NOTES AND TOLERANCES: (UNLESS OTHERWISE SPECIFIED)				CALIFORNIA INSTITUTE OF TECHNOLOGY MASSACHUSETTS INSTITUTE OF TECHNOLOGY		PART NAME aLIGO TMS TELESCOPE SECONDARY MIRROR ASSEMBLY	
MATERIAL N/A		FINISH N/A μinch		SYSTEM ADVANCED LIGO		SUB-SYSTEM AOS	
NEXT ASSY D1102361				DESIGNER K. MAILAND 16 DEC 2011		SIZE DWG. NO. B D1102365	
				DRAFTER E.SANCHEZ 02 APR 2012		REV. v2	
				CHECKER SEE DCC		SCALE: NONE PROJECTION:	
				APPROVAL SEE DCC		SHEET 1 OF 3

D1102365 aLIGO TMS Telescope Secondary Mirror Assembly, PART PDM REV: X-038, DRAWING PDM REV: X-011

ISO VIEW

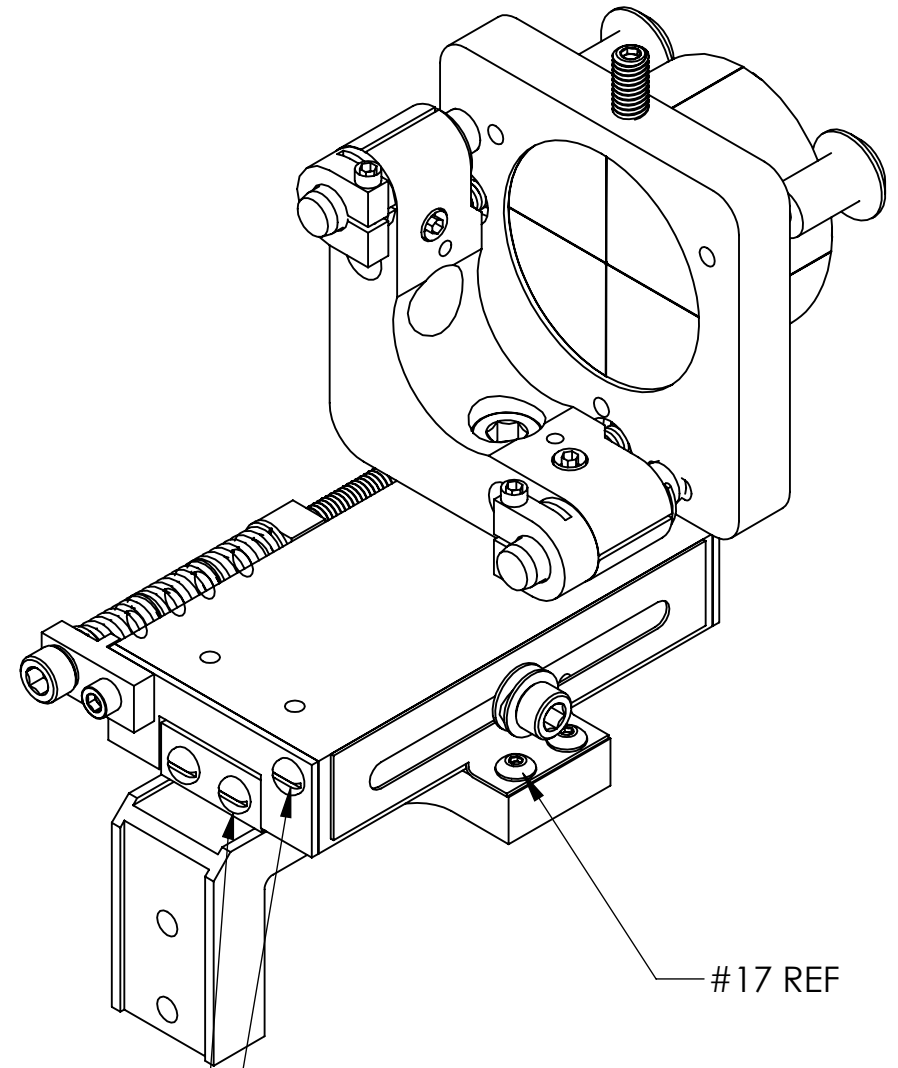
ALL END PLATE SCREWS ARE NOW TO BE VENTED

Note this part #17 is either a vented SHCS 1/4 long or one of the button head screws taken from the end of the slide

SIZE	DWG. NO.	REV.
B	D1102365	v2
SCALE: NONE	PROJECTION:	SHEET 3 OF 3

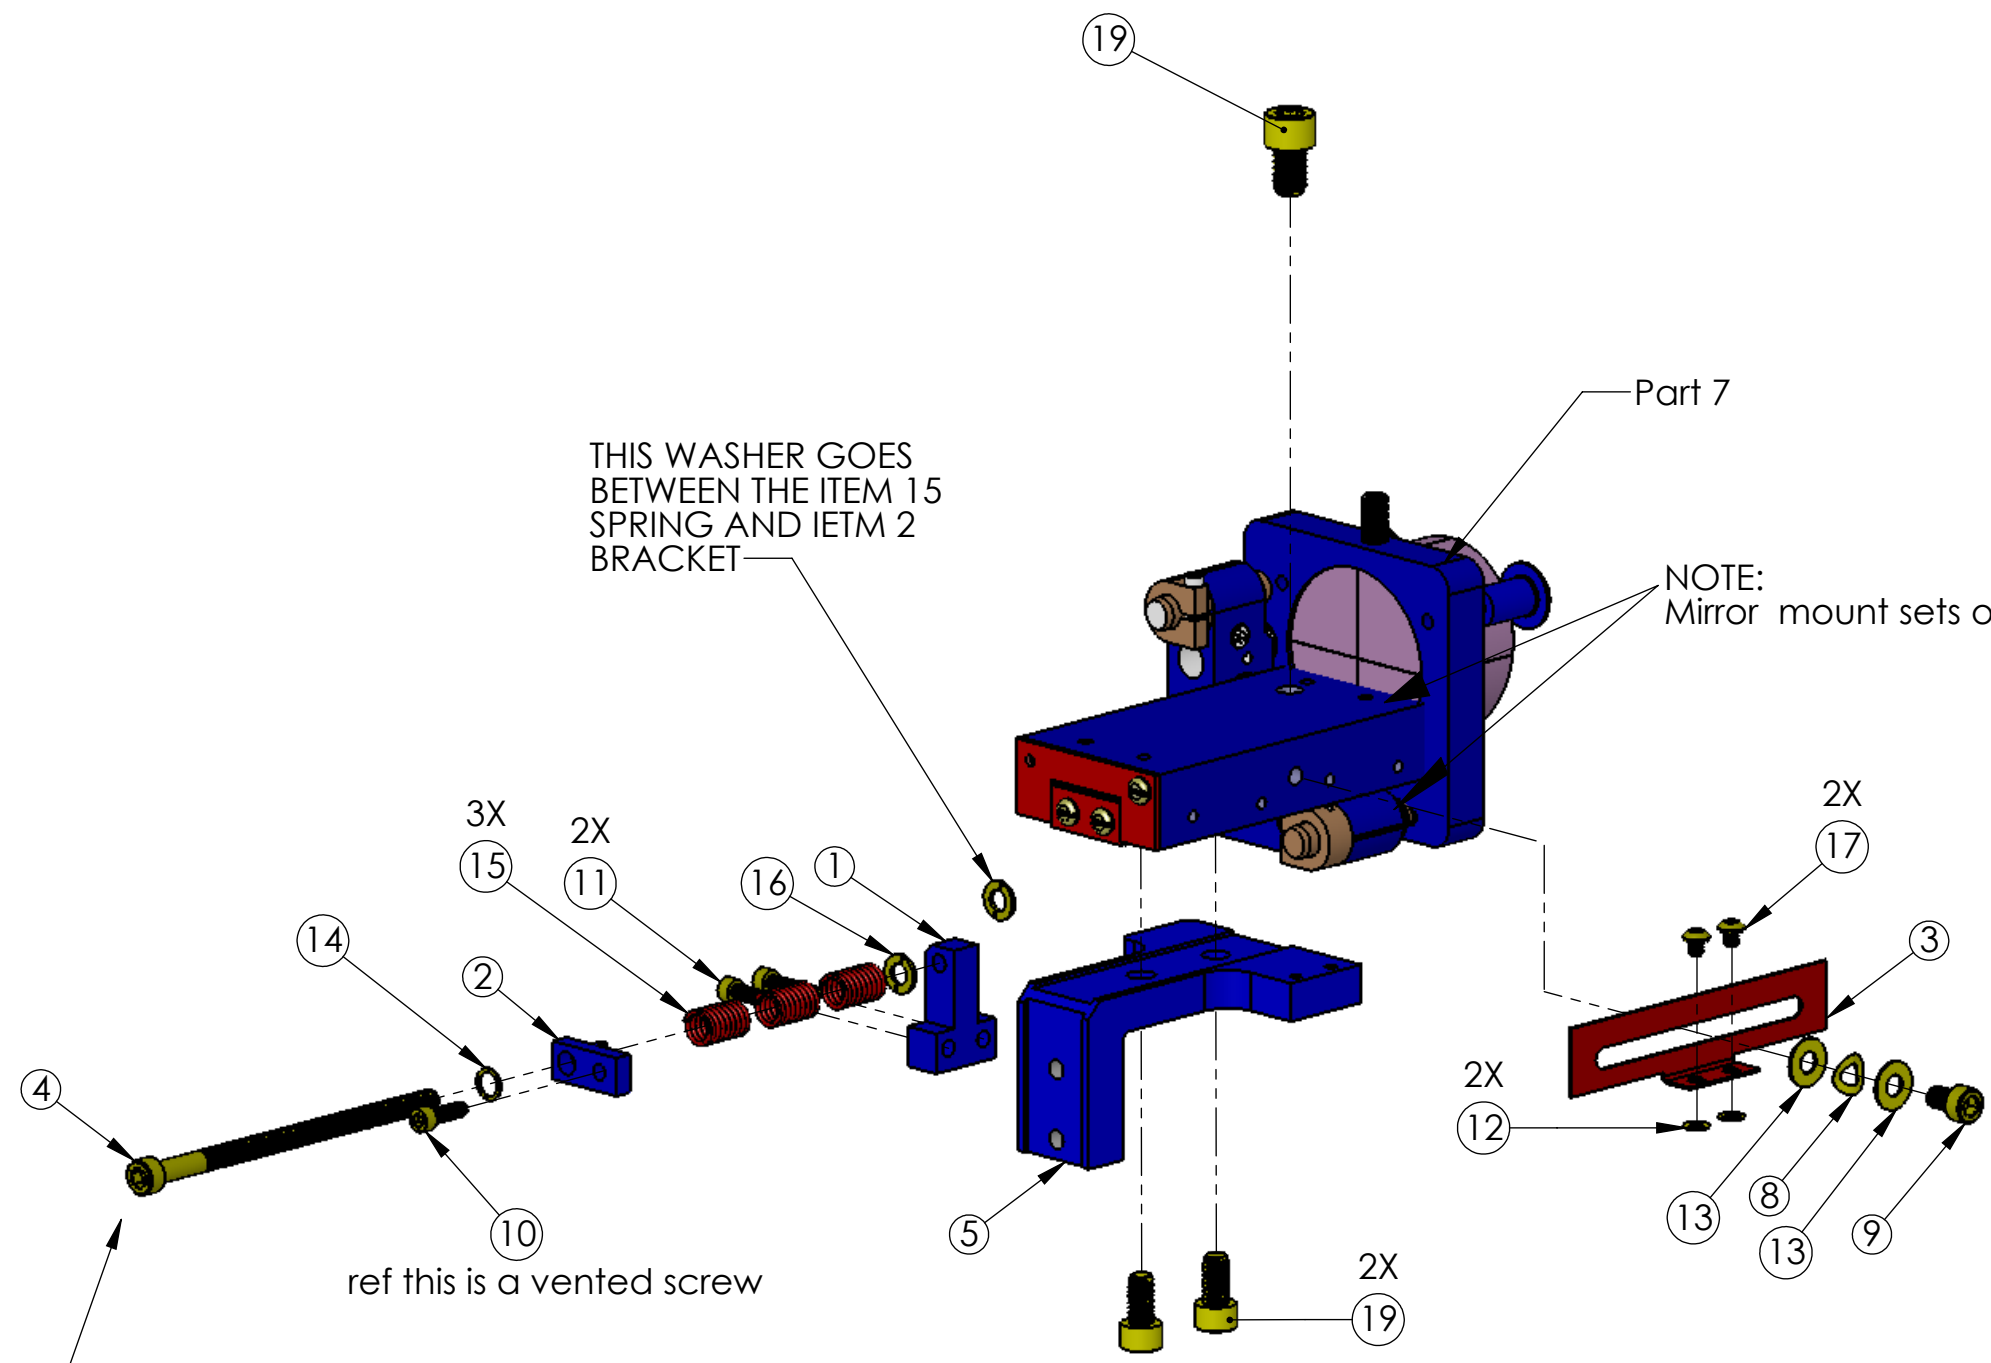
THIS WASHER GOES
BETWEEN THE ITEM 15
SPRING AND IETM 2
BRACKET

ref this is a vented screw
